Sudbury to Hudson TRP Week of 3/17/2025

Epsilon Team Full SWPPP Inspection Report(s)

CONSTRUCTION MONITORING REPORT
Sudbury to Hudson Transmission Project

Project Name:
Sudbury to Hudson Transmission Reliability Project

Epsilon Associates Inc.		PHOTOGRAPHIC LOG	
Client Name: Eversource		Site Location: Sudbury to Hudson Transmission Reliability Project	Town: Hudson
Photo No.: 2	Date: 3-18-2025

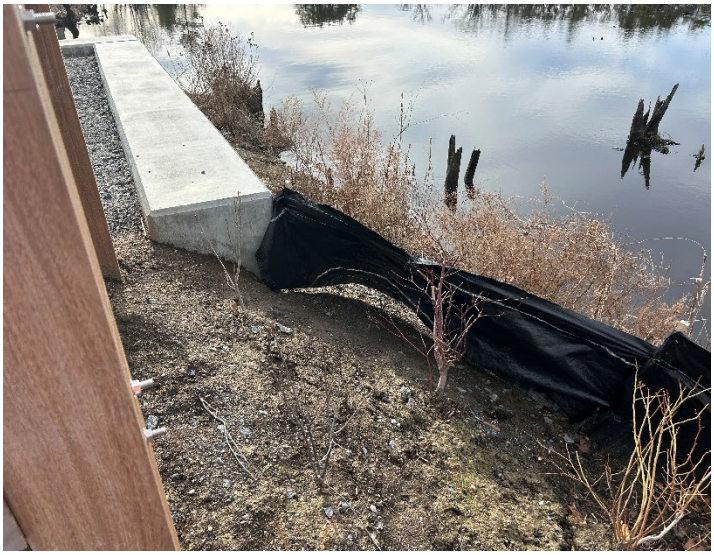
-Small section of silt fencing on west side of bridge 130 needs to be keyed in.

Description: View of silt fence at bridge 130. Silt fence should be keyed in. Facing southeast.

Epsilon Associates Inc.	PHOTOGRAPHIC LOG	
Client Name: Eversource	Site Location: Sudbury to Hudson Transmission Reliability Project	Town: Hudson
Photo No.: 3 / Date: 3-18-2025

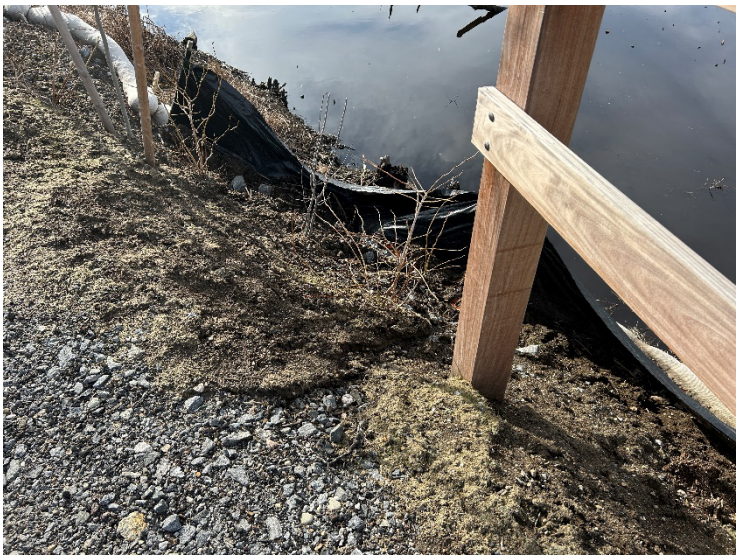
-Rill erosion noted at bridge 130 and near Station 347 in segment 6.

Description: View of rill erosion at the southeast corner of bridge 130. Facing southeast.

Epsilon Associates Inc.	PHOTOGRAPHIC LOG	
Client Name: Eversource	Site Location: Sudbury to Hudson Transmission Reliability Project	Town: Hudson
Photo No.: 8 / Date: 3-18-2025

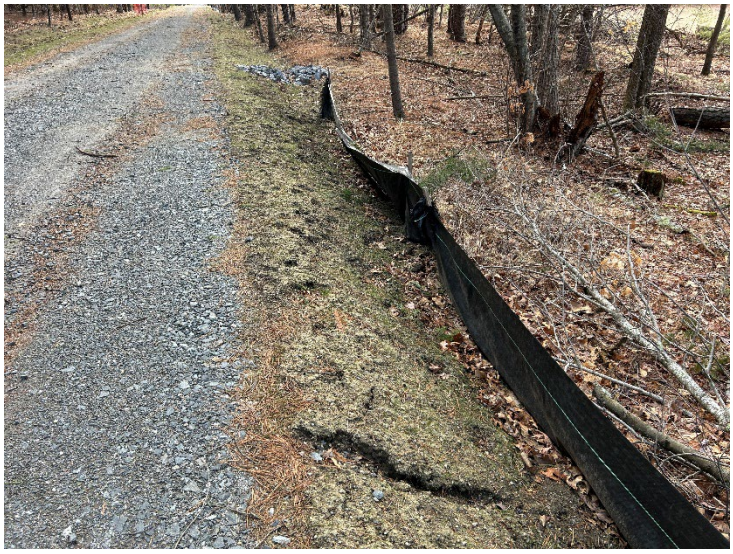
Description: View of rill erosion in segment 6 near station 347. Facing east.

Epsilon Associates Inc.	PHOTOGRAPHIC LOG	
Client Name: Eversource	Site Location: Sudbury to Hudson Transmission Reliability Project	Town: Sudbury
Photo No.: 1 / Date: 3-18-2025

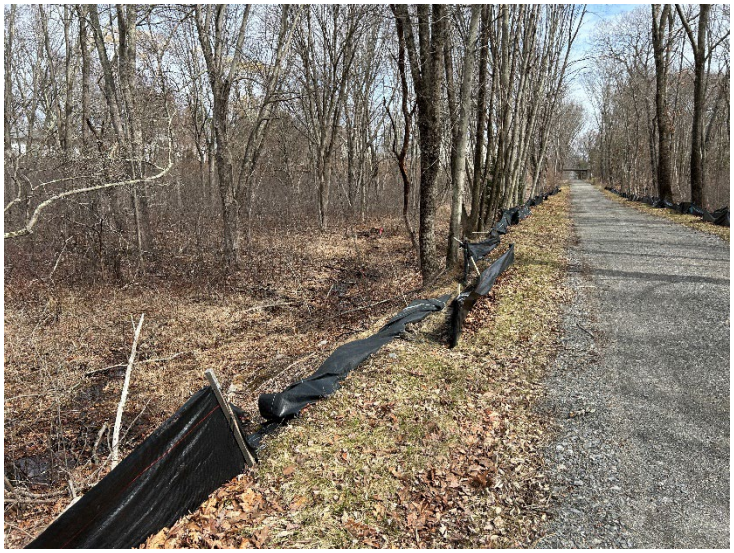
-Silt fencing is down in segment 8 at approximately station 409+50, in segment 14 at the wetland replication area, at approximately station 749, station 745+50, and near bridge 127, north side of the work area.

Description: View of damaged silt fence at approximately station 749 in segment 14. Facing east.

Epsilon Associates Inc.	PHOTOGRAPHIC LOG	
Client Name: Eversource	Site Location: Sudbury to Hudson Transmission Reliability Project	Town: Sudbury
Photo No.: 2 / Date: 3-18-2025

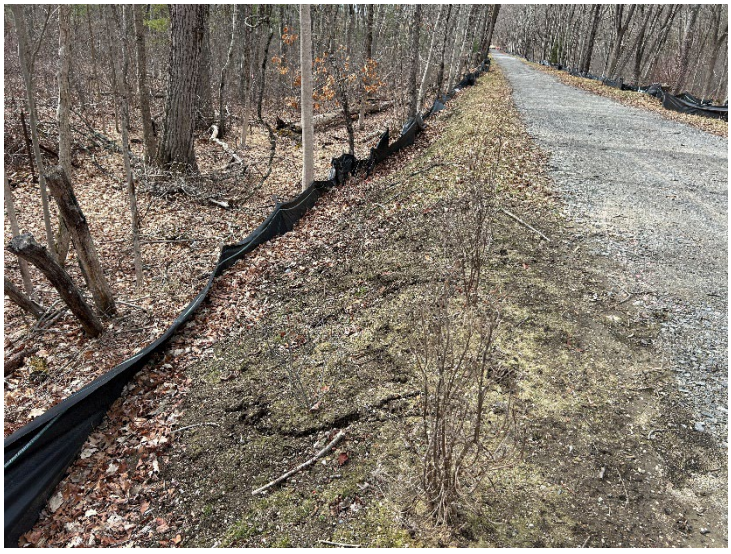
-Rill erosion noted around bridge 128, in segment 12 near Union Ave, and on the hydroseeded slope between approximately Station 738+00 and 741+00 in segment 14.

Description: View of rill erosion on the hydroseeded slope between approximately Station 738+00 and 741+00 in segment 14. Facing west.

Epsilon Associates Inc.	PHOTOGRAPHIC LOG	
Client Name: Eversource	Site Location: Sudbury to Hudson Transmission Reliability Project	Town: Sudbury
Photo No.: 3 / Date: 3-18-2025

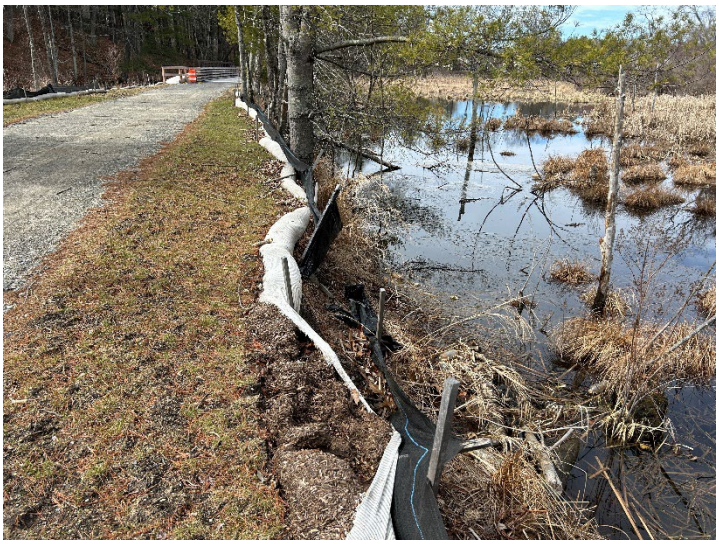
Description: View of damaged E&S controls near bridge 127 in segment 14. Facing west.

Epsilon Associates Inc.	PHOTOGRAPHIC LOG	
Client Name: Eversource	Site Location: Sudbury to Hudson Transmission Reliability Project	Town: Sudbury
Photo No.: 5 / Date: 3-18-2025

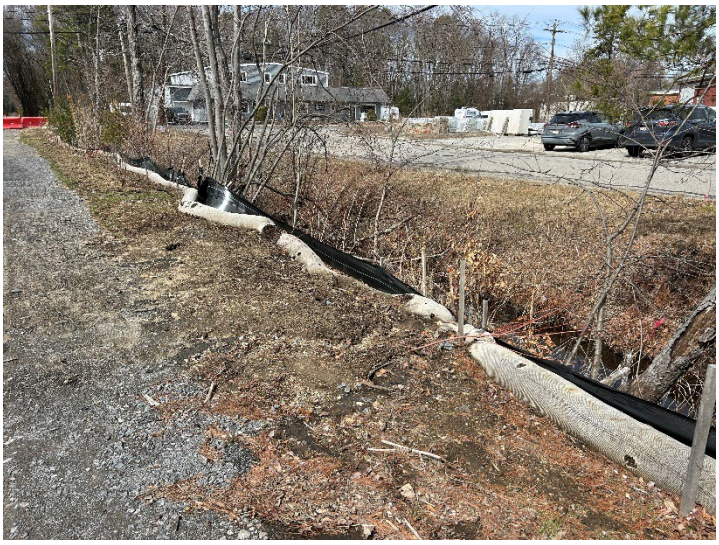
Description: View of rill erosion in segment 12 near Union Ave. Facing northwest.

Epsilon Associates Inc.	PHOTOGRAPHIC LOG	
Client Name: Eversource	Site Location: Sudbury to Hudson Transmission Reliability Project	Town: Sudbury
Photo No.: 6 / Date: 3-18-2025

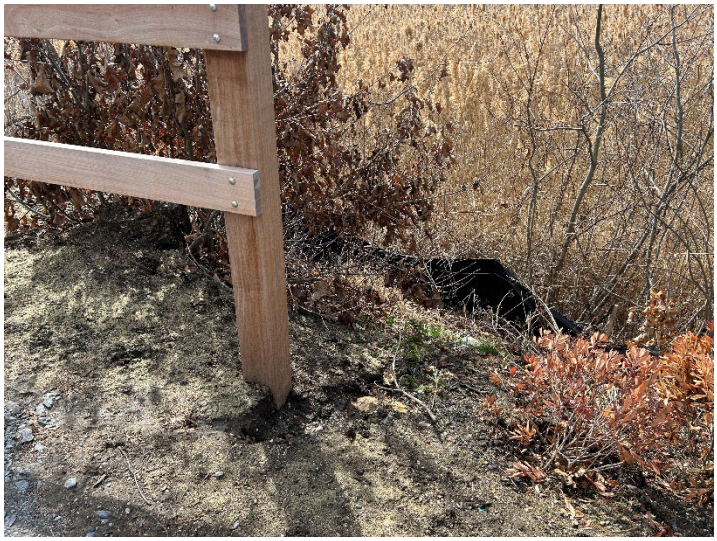
Description: View of rill erosion at the southwest corner of bridge 128. Facing south.

Epsilon Associates Inc.	PHOTOGRAPHIC LOG	
Client Name: Eversource	Site Location: Sudbury to Hudson Transmission Reliability Project	Town: Sudbury
Photo No.: 7 / Date: 3-18-2025

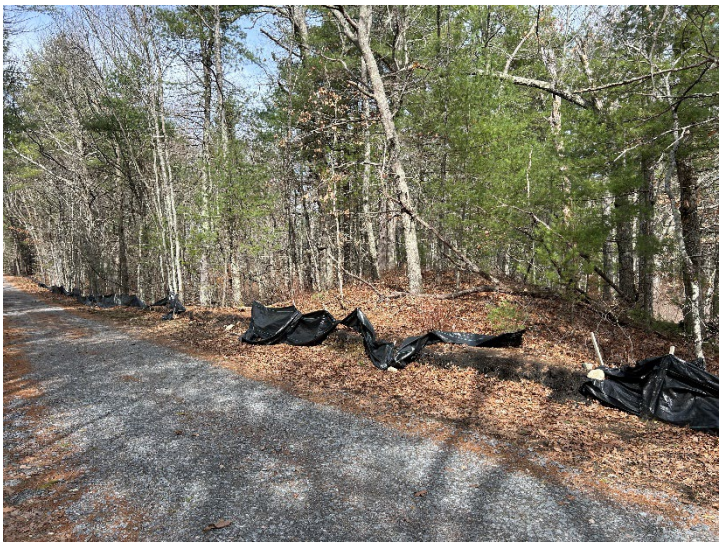
Description: View of damaged silt fence at approximately station 409+50 in segment 8. Facing northwest.
